Office Action Summary

09/738,979

UMEMOTO ET AL.

Fig.3

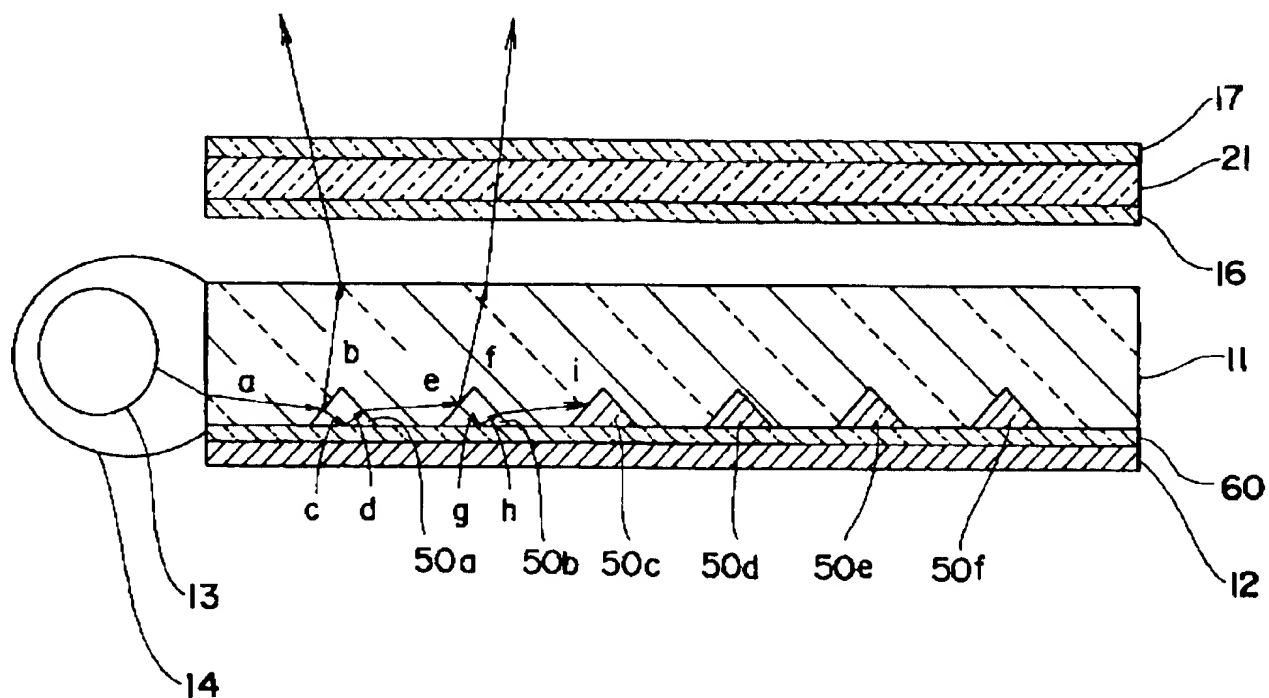
As to claim 1, Yuuki discloses in Figures 2, 3, and 4 (col. 5, line 19 through col. 8, line 52, especially col. 5, lines 45-55) a liquid-crystal display (LCD) device comprising: a transmission type liquid-crystal display panel, 21, including a liquid-crystal cell; a light source, 13, disposed on at least one side surface of said liquid-crystal display panel; and a light guide plate, 11, (Applicant's optical path changing sheet) disposed on a back side opposite to a visual side of said liquid-crystal display panel and having optical path changing slopes, 50a through 50f, by which incident light from said light source is reflected toward said visual side of said liquid-crystal display device (ray traces b and f).

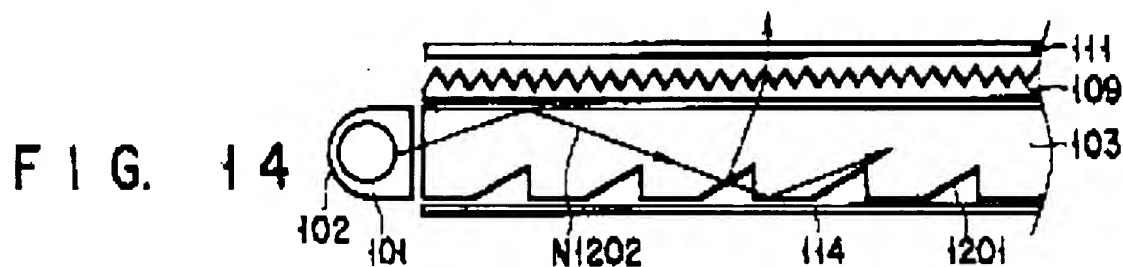
As to claim 2, Yuuki discloses in Figures 2, 3, and 4 (col. 5, line 19 through col. 8, line 52, especially col. 5, lines 19-22) the liquid-crystal display device according to claim 1, wherein said liquid-crystal display panel further includes a polarizer, 16, disposed on one or each, 17, side of said liquid-crystal cell, 21.

FIG. 5B

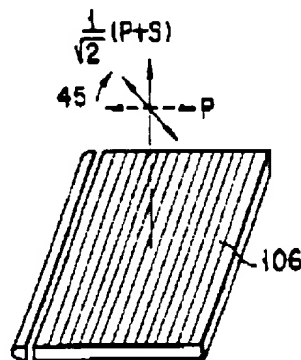
As to claim 10, Taira discloses in Figures 5B, 14, and 15 (embodiment 11, col. 13, line 50 through col. 15, line 16, especially col. 14, line 65 through col. 15, line 2) the liquid-crystal display device according to claim 9, wherein said prismatic concave portions are constituted by continuous grooves extended from one end of said sheet to the other end of said sheet in a ridgeline direction parallel to or inclined to a side surface of said liquid-crystal display panel on which said light source is disposed.

FIG. 10A

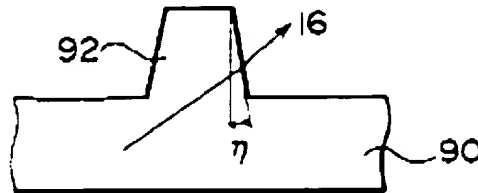
Miyashita teaches in Figure 10A the use of convex prismatic structures shaped substantially like a trapezoid in section to make manufacture by injection molding easier (col. 15, lines 58-67).

Miyashita is evidence that ordinary workers in the art of liquid crystals would find the reason, suggestion, or motivation to use convex prismatic structures shaped substantially like a trapezoid in section to make manufacture by injection molding easier.
